Request for Administrative Amendment Approval

RE: U-HAUL – 4TH AND I-40
REQUEST FOR ADMINISTRATIVE AMENDMENT
2217 4TH STREET NW ALBUQUERQUE, NM 87107
TR C OF ALEXANDER CENTER (EXCL S'LY PORT OUT TO R/W)
ZONE ATLAS PAGE H-14-Z

Tierra West, LLC, on behalf of U-Haul, requests approval for an Administrative Amendment to the Site Development Plan for the above referenced project. The project is located at 2217 4th Street NW, Albuquerque, NM 87107. The request is to revise the loading dock area from two docks to one dock as shown on the attached revised Traffic Circulation Layout.

U-HAUL
4TH AND I-40
TRAFFIC CIRCULATION
LAYOUT

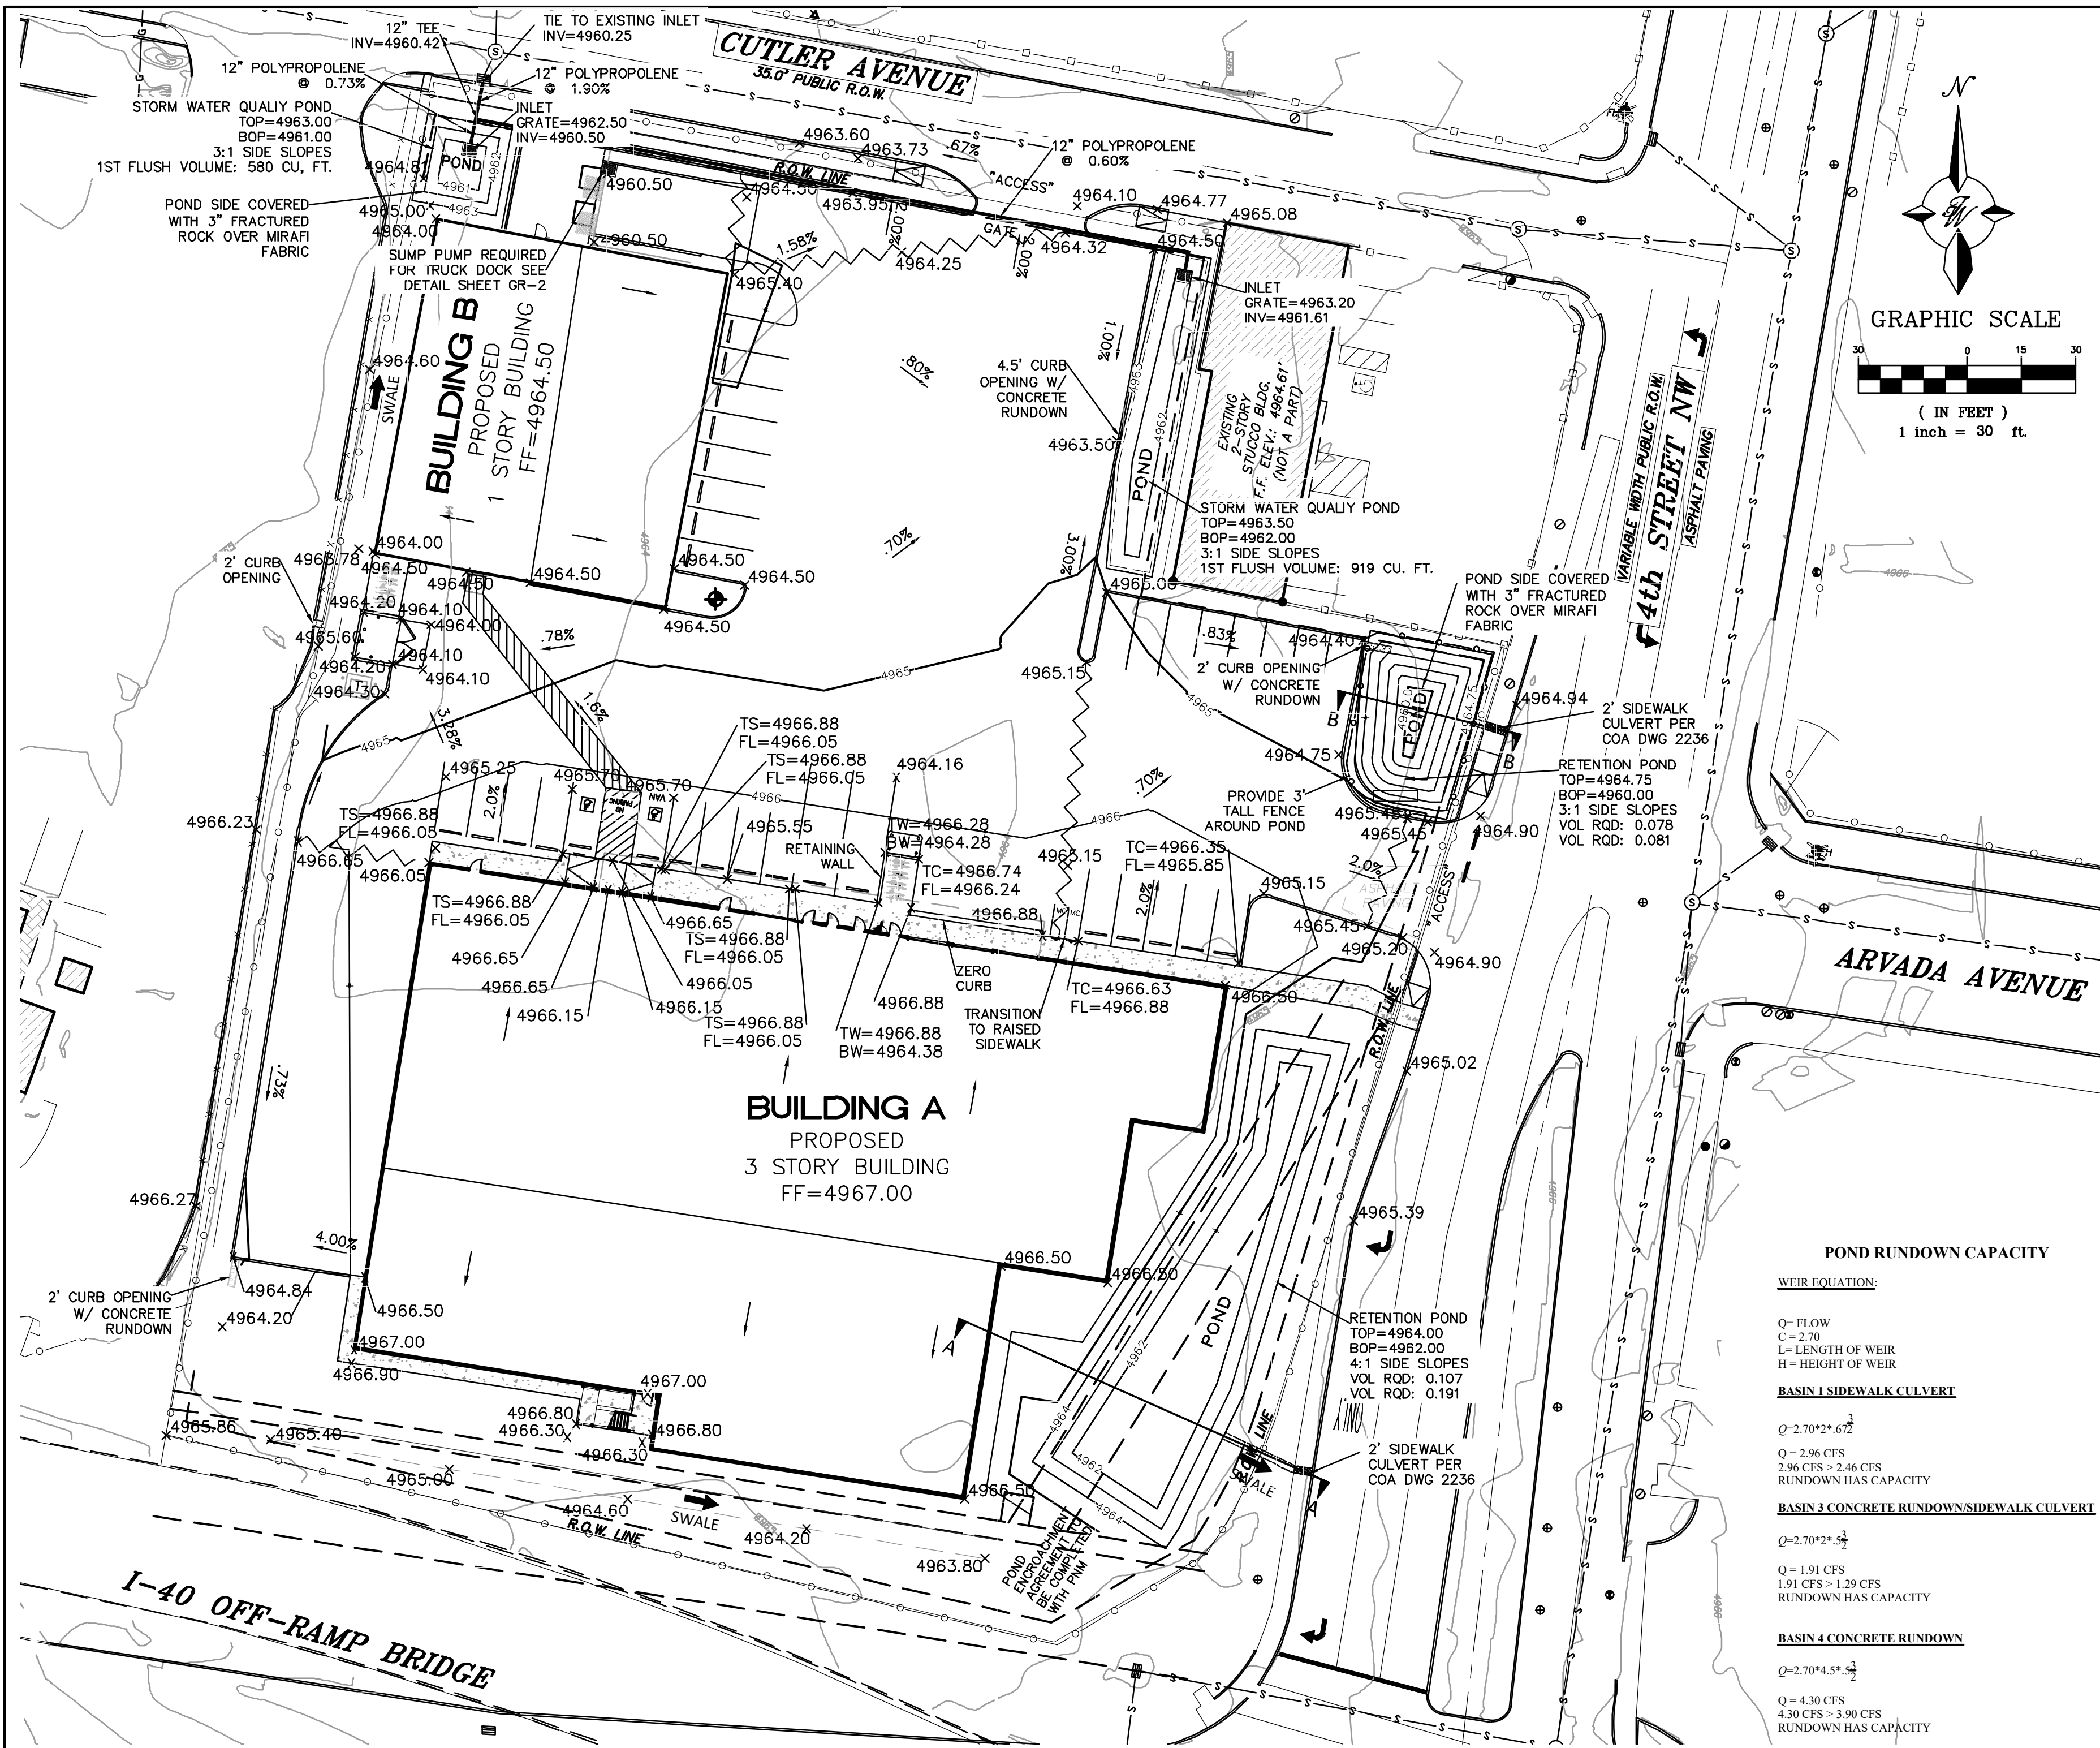
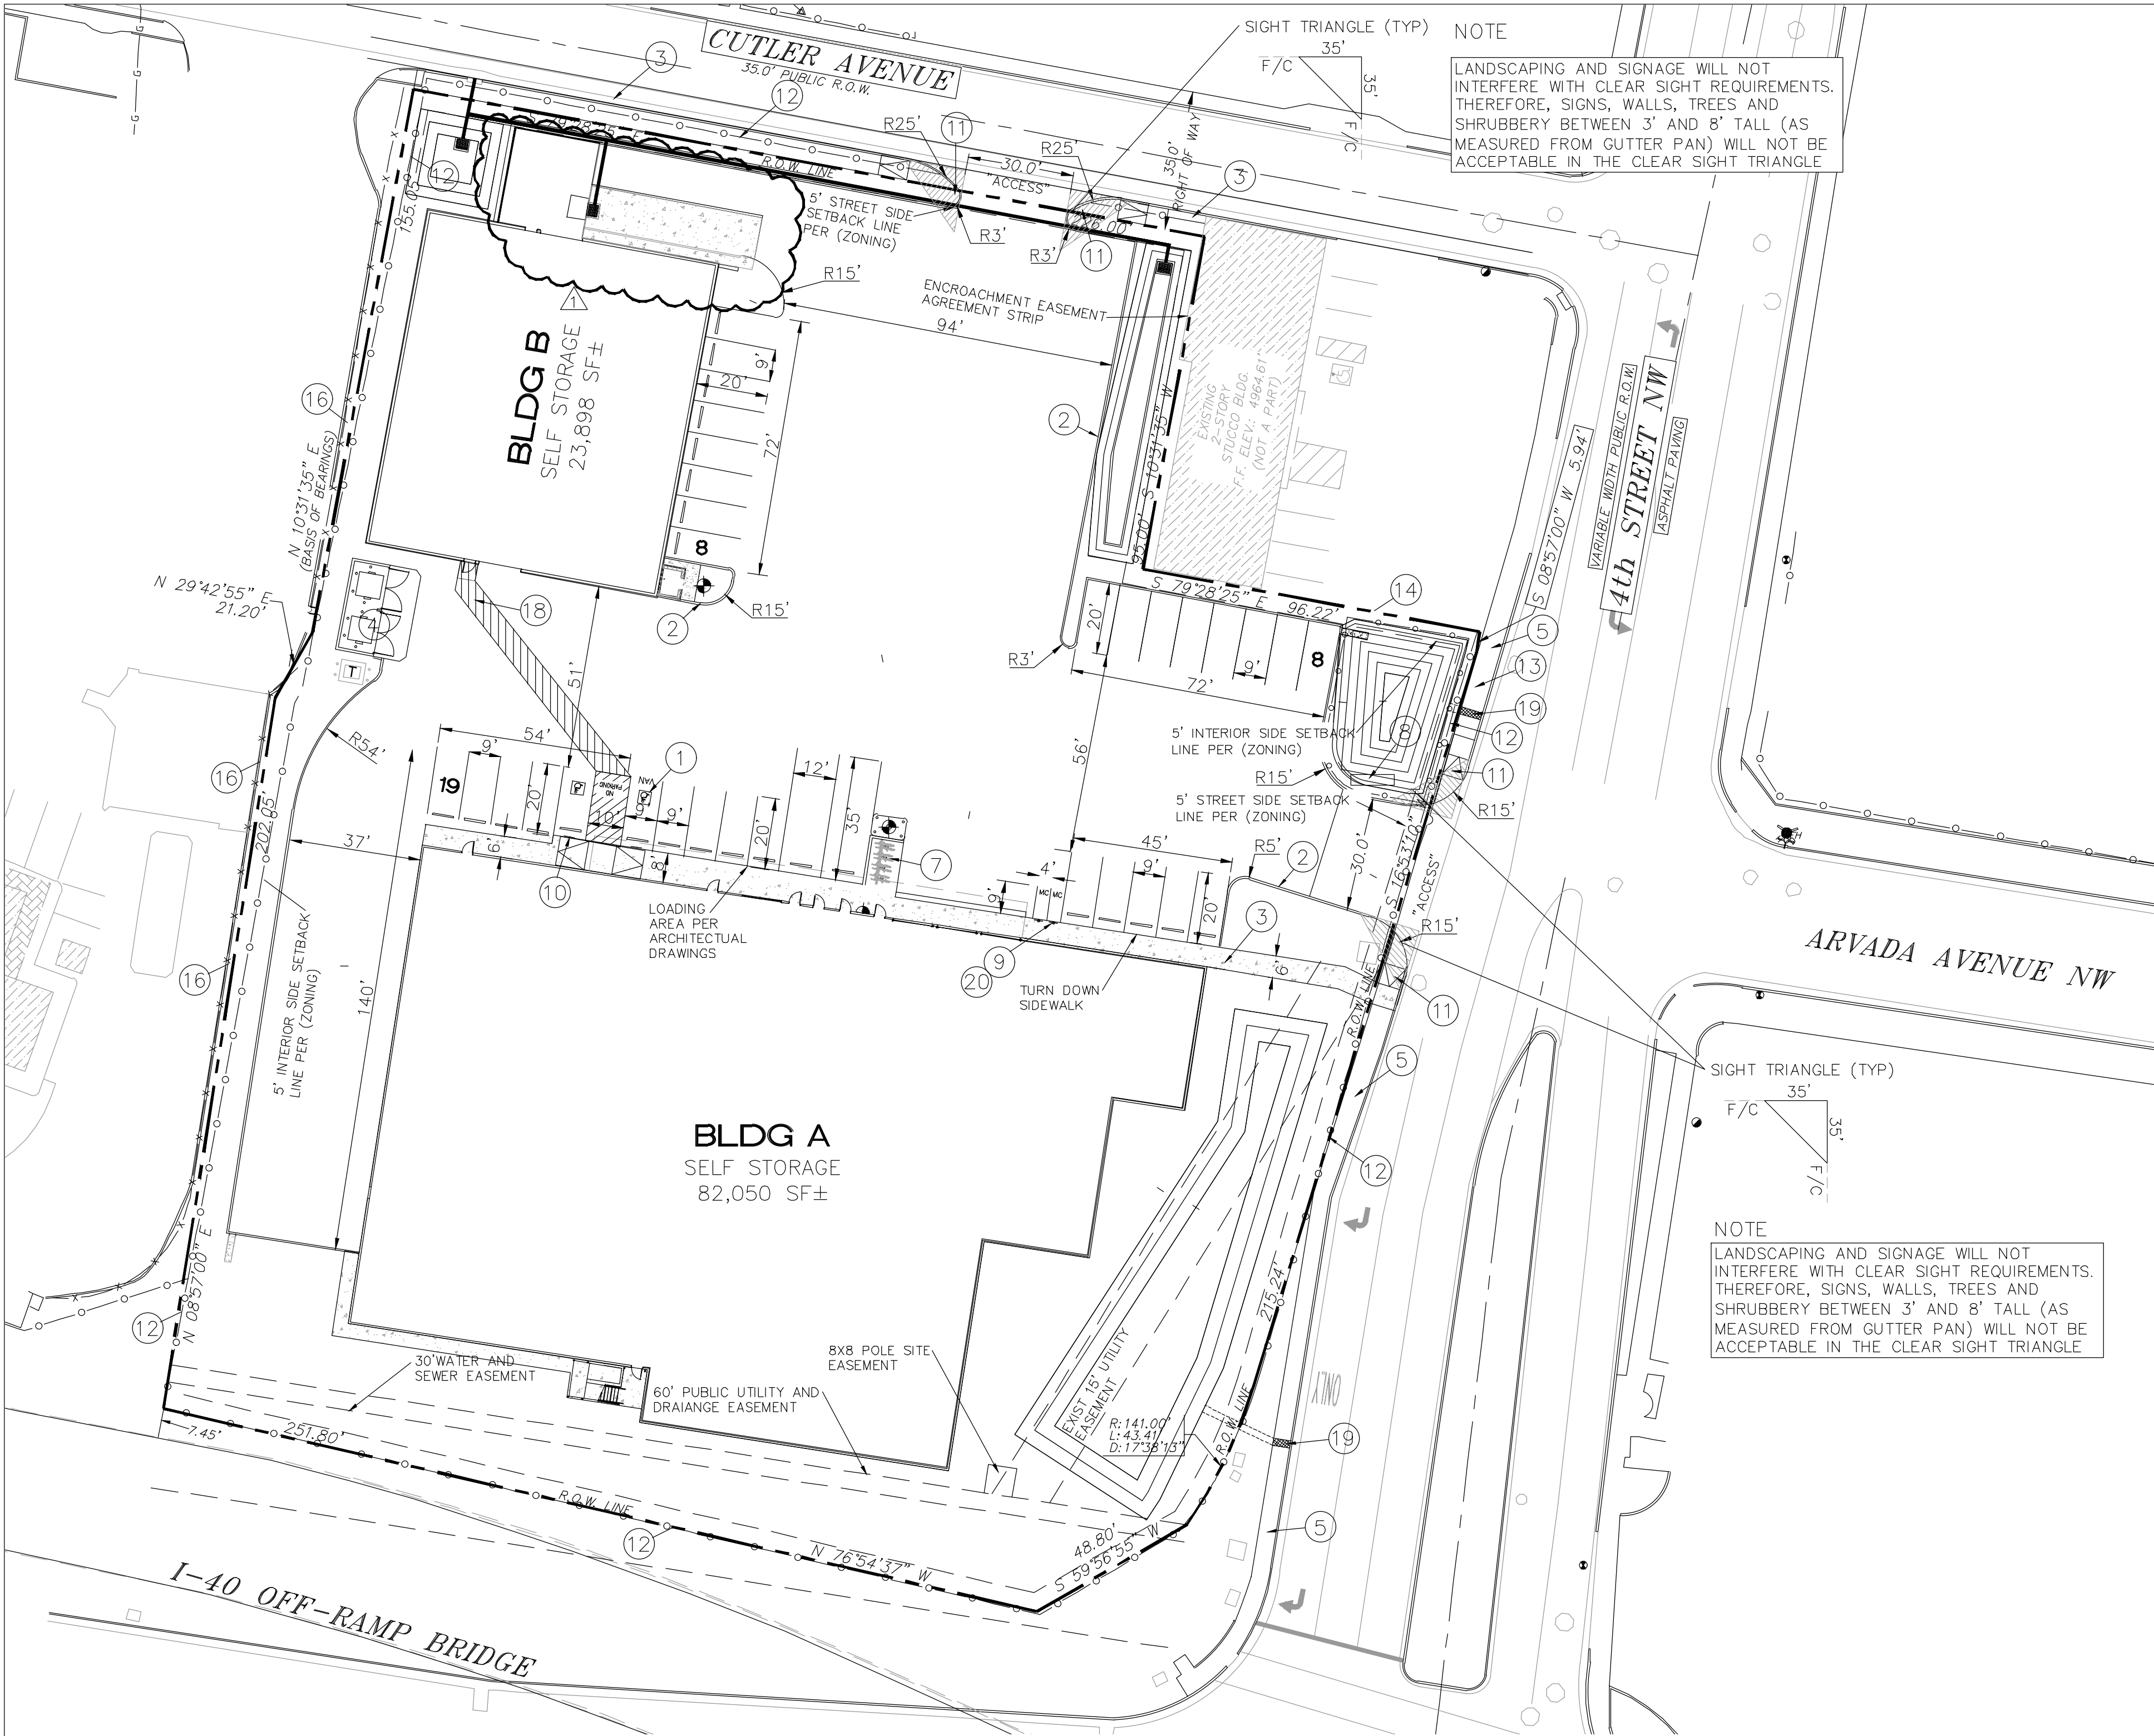
This project construction was delayed due to the COVID Pandemic and during that period market conditions dictated the need for only one loading dock. The asphalt area north of the single dock will be an at grade forklift access to the dock area. Attached is the approved Site Plan for Building Permit Plan that we would like to amend to show the single loading dock.

1	08-09-2022	REVISE LOADING DOCK AND FORKLIFT APPROACH	RMG
NO.	DATE	REMARKS	BY
REVISIONS			
ENGINEER'S SEAL		DRAWN BY	
		RMG	
		DATE	
		2019070-TCL	
		SHEET #	
		C-1	
		JOB #	
		2019070
